Carencro City Hall Expansion

Carencro, Louisiana

June 8, 2026

NEW INTERIM LOCATION OF EXISTING AC CONDENSING UNITS

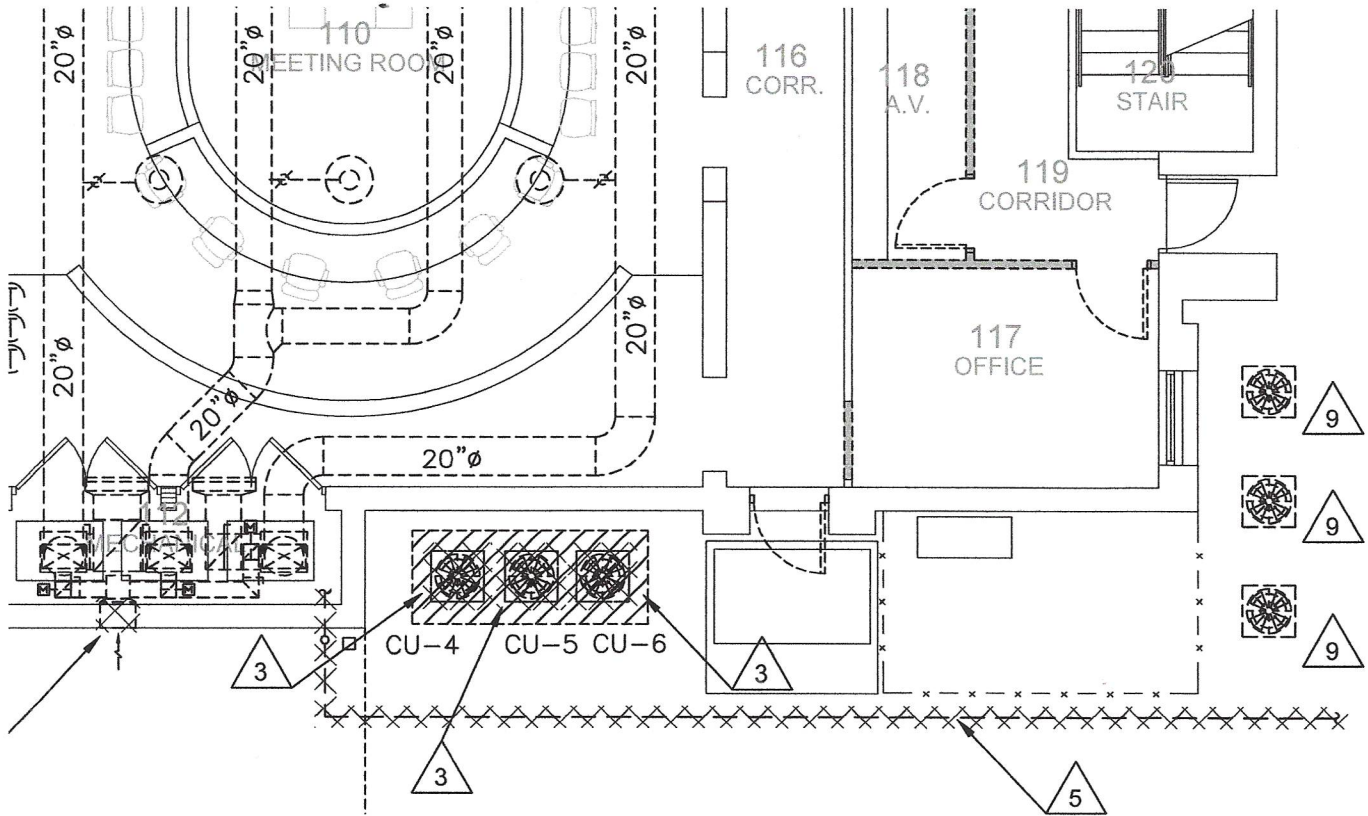
- a. Sheet G.001R –
 - i. The attached drawing labeled "New Interim Location of Existing AC Condensing Units" and dated June 8, 2026, is provided to show where the existing AC condensers on the south side of the existing building are to be located during construction. See Mechanical and Electrical Clarifications elsewhere in this addendum and for more information. See Attachment No. Two (2).

- 1 EXISTING AC UNITS (SHOWN ON D.100) TO BE MOVED TO THIS TEMPORARY AREA.
- 2 PROPOSED BRICK SCREEN TO BE BUILT AFTER THE EXISTING AC UNITS ARE MOVED TO THEIR PERMANENT LOCATION.
- 3 EXTEND TEMPORARY CHAIN LINK FENCE TO HERE.

ADDENDUM NO. 6
 ATTACHMENT NO. 2
 PAGE 2 OF 2
 JUNE 8, 2026

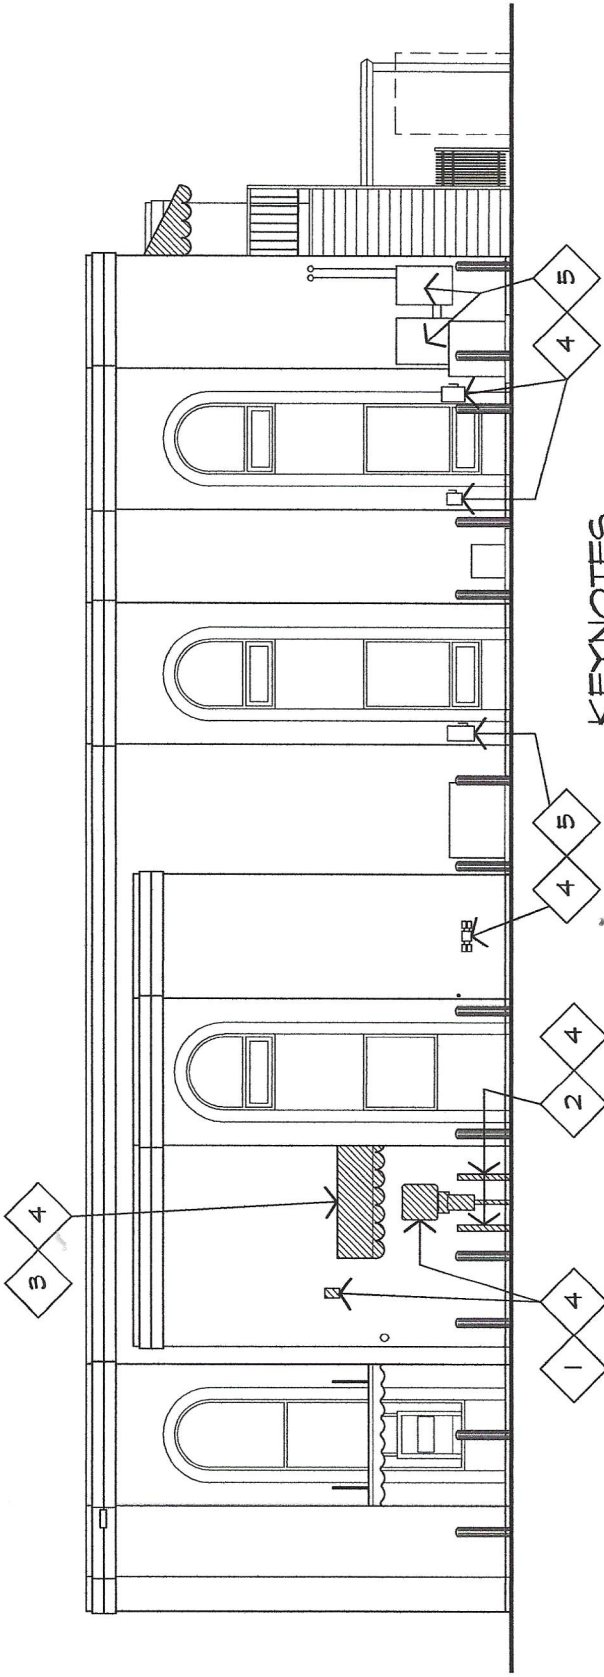
- i. Contractor shall include all work as indicated on attached 8.5”x11”, page 2 of 2 showing the interim location of the existing AC condensing units. See Attachment No. Two (2).

- b. Electrical.
 - i. Contractor shall refer to mechanical demo sketch (Attachment No. Two (2)) for temporary location of the existing condensing units. Contractor shall disconnect and relocate electrical feeders and safety switches from current location to new temporary location shown on provided mechanical sheet. New conduit stub out from building shall penetrate above wire way at the southeast electrical yard. Conduit shall head east and drop down to wireway at condensing unit locations. The existing safety switches shall be relocated to new location and mounted to Unistrut racks. All circuitry shall be re-routed/extended to new location.

- 3** CONTRACTOR SHALL REMOVE THE EXISTING CONDENSING UNITS AND INSTALL IN NEW LOCATION INDICATED ON SHEET M.100.
- 5** REMOVE EXISTING CONDENSATE DRAIN LINE SHOWN HATCHED. A NEW HUB DRAIN WILL BE INSTALLED TO CAPTURE CONDENSATE FROM EXISTING UNITS AS PART OF THIS PROJECT.
- 9** EXISTING CONDENSING UNIT SHALL BE MOVED TO THIS TEMPORARY LOCATION DURING A TIME OF CONSTRUCTION OF NEW ADDITION. REWORK EXISTING REFRIGERANT PIPING, ADDING NEW PIPING AND ACCESSORIES AS REQUIRED TO MAINTAIN PROPER OPERATION OF UNIT DURING CONSTRUCTION.

**SUPPLEMENT OF A.1/D.200
DEMOLITION WEST ELEVATION**

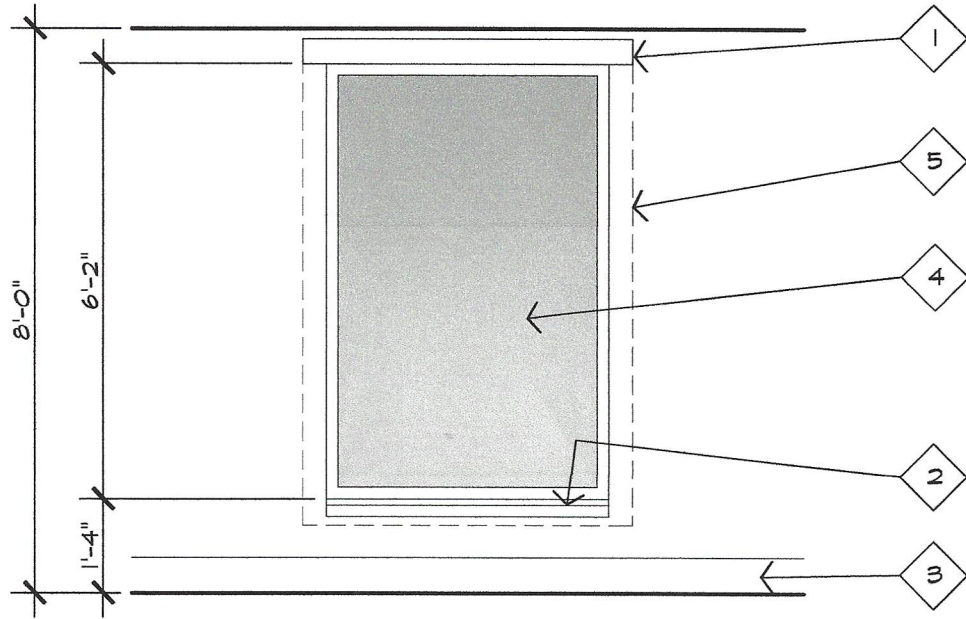
- i. A supplement to drawing A.1/D.200 is included in this addendum and titled “Supplement of A.1/D.200 – Demolition West Elevation”. This drawing is a supplement to drawing A.1 on D.200, and does not replace it. All Keynotes shown on A.1/D.200 still apply. Only additional Keynotes are shown on the attachment. See Attachment No. Three (3).
- ii. In drawing D.1/D.200, The existing electrical devices in the electrical yard on the right side of the drawing are to be painted. The color will be selected by the architect, but the intent is to match the color of the brick.

- 1 REMOVE EXISTING PAYMENT PEDESTAL, SIGN, AND LIGHT FIXTURE.
- 2 REMOVE EXISTING BOLLARDS.
- 3 REMOVE EXISTING ANNING & FRAME WORK.
- 4 THIS IS PART OF AN ALTERNATE. IT IS NOT INCLUDED IN THE BASE BID. SEE SPECIFICATION SECTION 01030 ALTERNATES FOR DESCRIPTION.
- 5 PAINT EXISTING ELECTRICAL DEVICE. COLOR TO BE SELECTED BY ARCHITECT, BUT THE INTENT IS TO MATCH BUILDING.

3. See attached drawings labeled “Roller Shade Configurations,” dated June 8, 2026, for description of sizes of each type. See Attachment No. Four (4).

- 1 SINGLE MANUAL ROLLER SHADE HOUSING.
- 2 SILL AND APRON. SEE A.11/A.001.
- 3 BASE. SEE FINISH SCHEDULE.
- 4 OPENING TYPE "B". (V.O.J. SIZE)
- 5 ROLLER SHADE IS TO BE 8" WIDER THAN OPENING (4" PER SIDE) AND 4" LOWER THAN SILL.

TYPICAL DUAL ROLLER SHADE CONFIGURATIONS - FIRST FLOOR

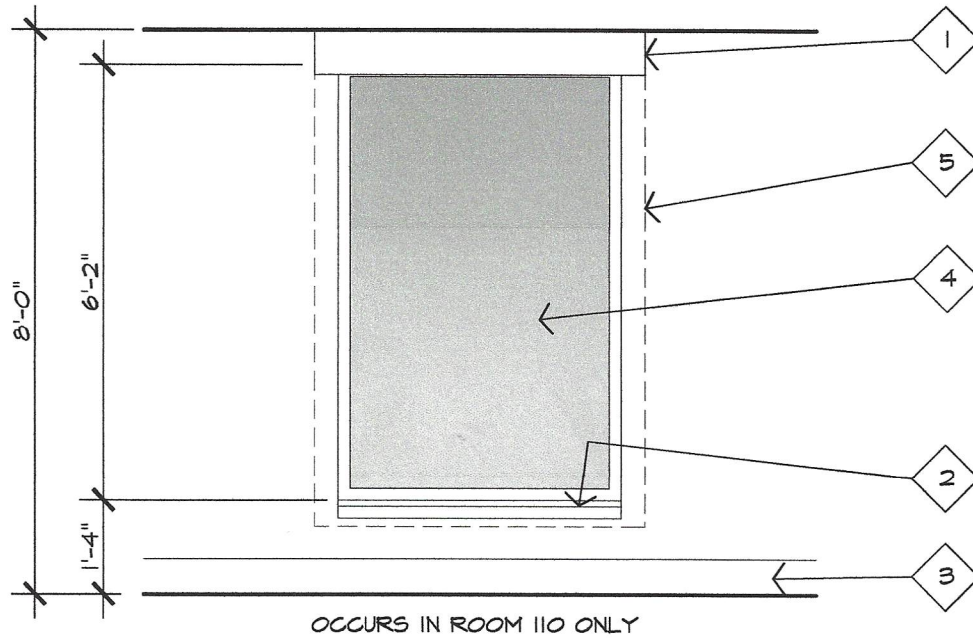
- 1 DUAL MOTORIZED ROLLER SHADE HOUSING. HUG CEILING, BUT HOUSING MAY EXTEND LOWER THAN HEAD OF OPENING (V.O.J.).
- 2 SILL AND APRON. SEE A.11/A.001.
- 3 BASE. SEE FINISH SCHEDULE.
- 4 OPENING TYPE "B". (V.O.J. SIZE)
- 5 ROLLER SHADE IS TO BE 8" WIDER THAN OPENING (4" PER SIDE) AND 4" LOWER THAN SILL.

TYPICAL SINGLE MANUAL ROLLER SHADE CONFIGURATIONS - SECOND FLOOR

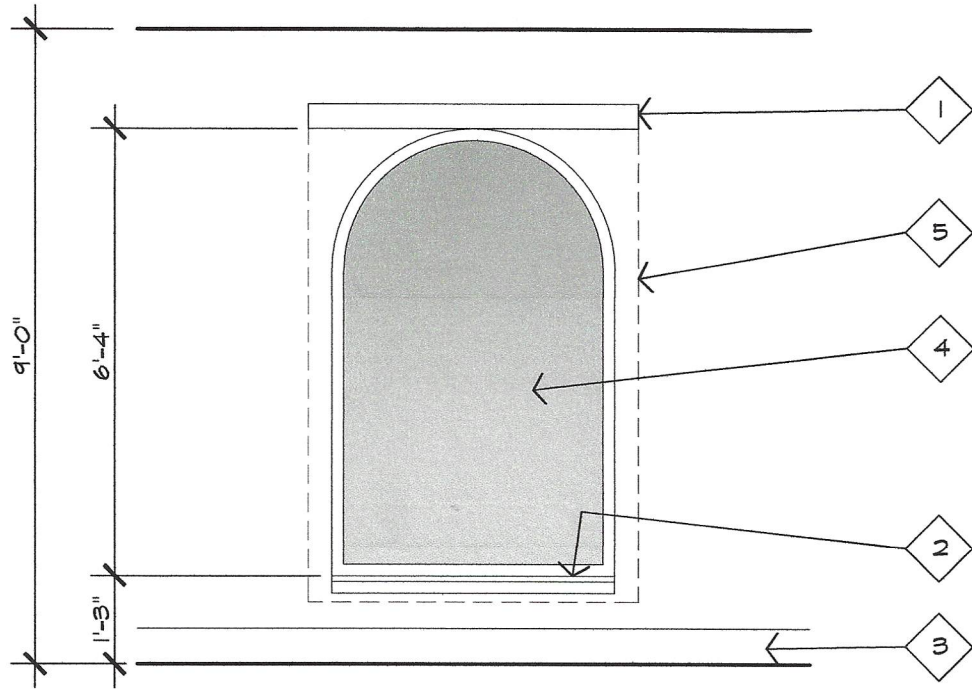
- 1 SINGLE MANUAL ROLLER SHADE HOUSING.
- 2 SILL AND APRON. SEE A.11/A.001.
- 3 BASE. SEE FINISH SCHEDULE.
- 4 OPENING TYPE "C". (V.O.J. SIZE)
- 5 ROLLER SHADE IS TO BE 8" WIDER THAN OPENING (4" PER SIDE) AND 4" LOWER THAN SILL.

TYPICAL DUAL ROLLER SHADE CONFIGURATIONS - SECOND FLOOR

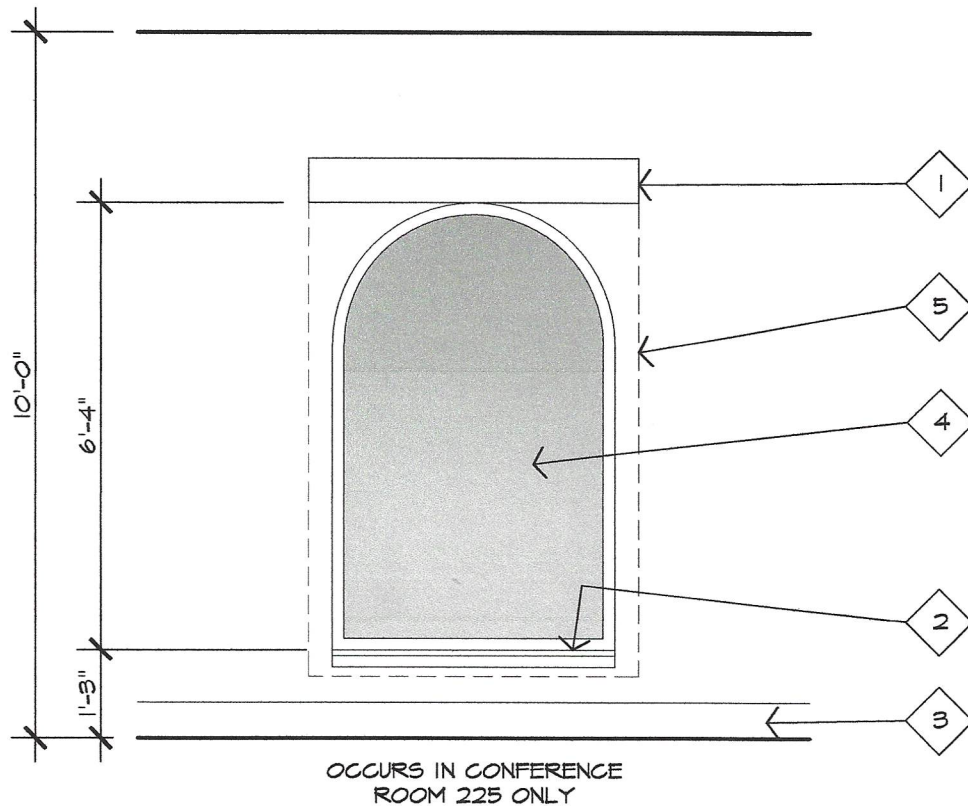
- 1 SINGLE MANUAL ROLLER SHADE HOUSING.
- 2 SILL AND APRON. SEE A.11/A.001.
- 3 BASE. SEE FINISH SCHEDULE.
- 4 OPENING TYPE "C". (V.O.J. SIZE)
- 5 ROLLER SHADE IS TO BE 8" WIDER THAN OPENING (4" PER SIDE) AND 4" LOWER THAN SILL.

TYPICAL SINGLE ROLLER SHADE CONFIGURATIONS

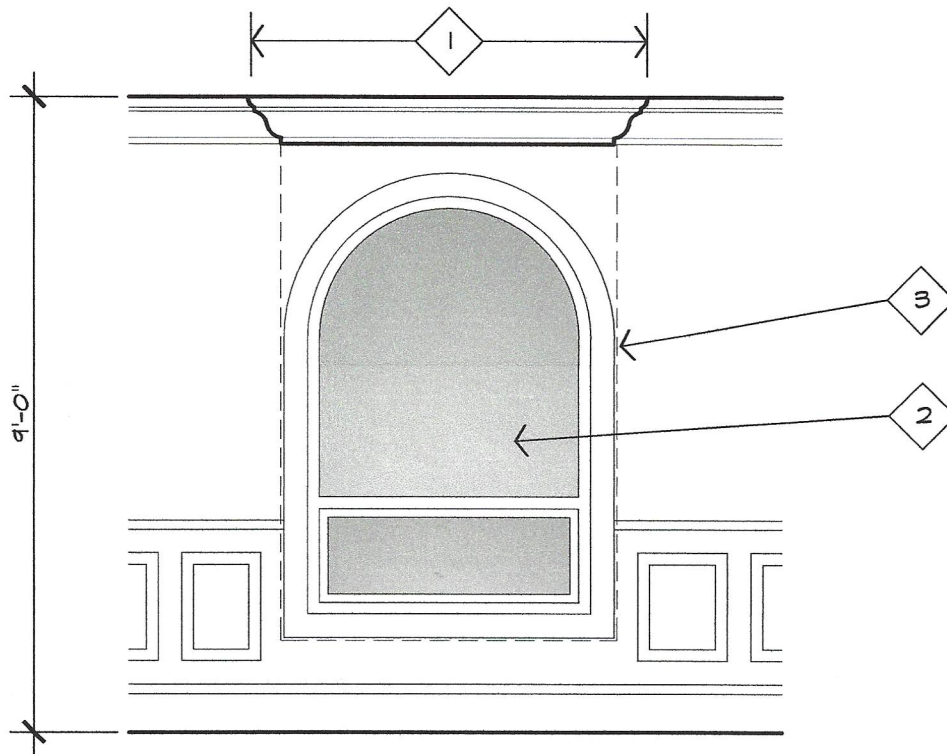
OCCURS TWICE IN ROOM 212 ONLY

- 1 CREATE POCKET WITH CROWN MOULDING TO HOUSE DUAL MOTORIZED ROLLER SHADE HOUSING.
- 2 EXISTING OPENING IS 4'-0" x 6'-0" TALL (V.O.J.).
- 3 ROLLER SHADE IS TO BE 8" WIDER THAN OPENING (4" PER SIDE) AND 4" LOWER THAN SILL.

ADDENDUM NO. 6
ATTACHMENT NO. 5
PAGE 1 OF 1
JUNE 8, 2026

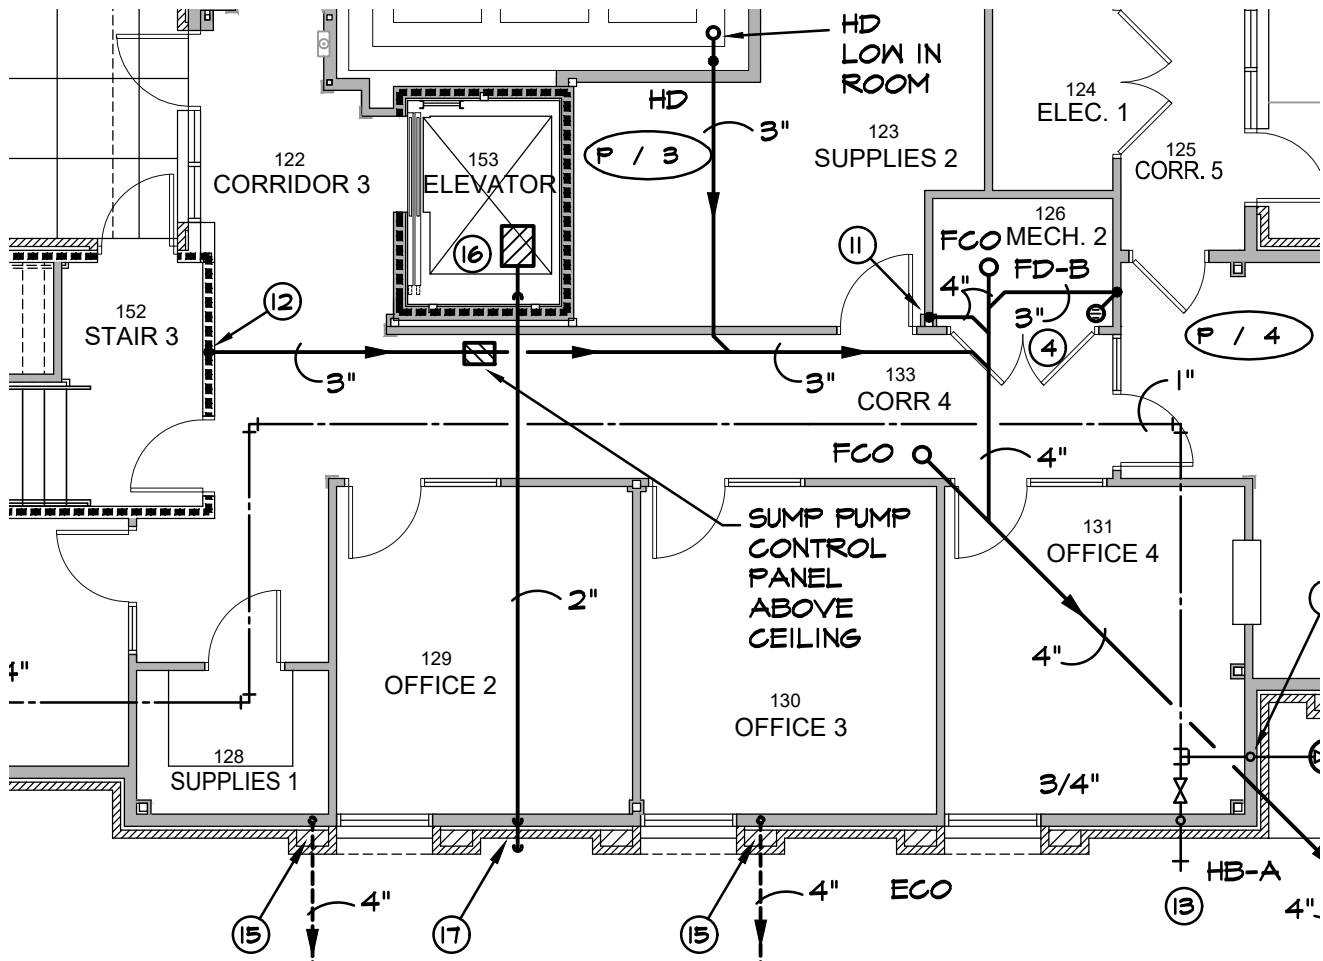
- i. Contractor shall include all work as indicated on attached Amendment of P.100R2, dated June 8, 2026. See Attachment No. Five (5).

- ii. Contractor shall provide receptacle at sump pump control panel location above ceiling. Wire receptacle to circuit C1-12. Refer to mechanical sketch (Attachment No. Five (5)) and coordinate final location with architect/engineer prior to rough-in.

16 PROVIDE SUMP AND PORTABLE SUMP PUMP FOR ELEVATOR PIT. ELECTRICAL CONTRACTOR SHALL PROVIDE GFI RECEPTACLE AT PIT ACCESS LADDER. PROVIDE POWER CORD WITH PLUG LONG ENOUGH TO CONNECT TO ELECTRICAL OUTLETS AT TOP OF PIT. RUN 2" COPPER DISCHARGE PIPE UP IN WALL TO ABOVE CEILING. RUN TO EXTERIOR WALL, DROP DOWN TO ABOVE 6" ABOVE GRADE AND TERMINATE AT SPLASH BLOCK. PUMP SHALL BE STANCOR SE40 OR APPROVED TO EQUAL, 0.4 HP, 120-1-60 ELECTRICAL SERVICE. INSTALL PUMP CONTROL PANEL ABOVE THE CEILING OUTSIDE OF THE ELEVATOR SHAFT WITH PHENOLIC LABEL STATING "ELEVATOR SUMP PUMP CONTROL PANEL" PLACED ON GRID OF THE CEILING. COORDINATE FINAL LOCATION OF PANEL AND LABEL WITH ENGINEER / ARCHITECT PRIOR TO INSTALLATION.

17 TURN 2" GALVANIZED STEEL PIPE DOWN AT 6" ABOVE GRADE. PLUMBING CONTRACTOR SHALL PROVIDE PERMANENT ALUMINUM SIGN ATTACHED TO WALL STATING "ELEVATOR PIT SUMP PUMP DISCHARGE DRAIN". COORDINATE EXACT SIZE, COLOR, AND MOUNTING LOCATION OF SIGN WITH ARCHITECT PRIOR TO INSTALLATION.
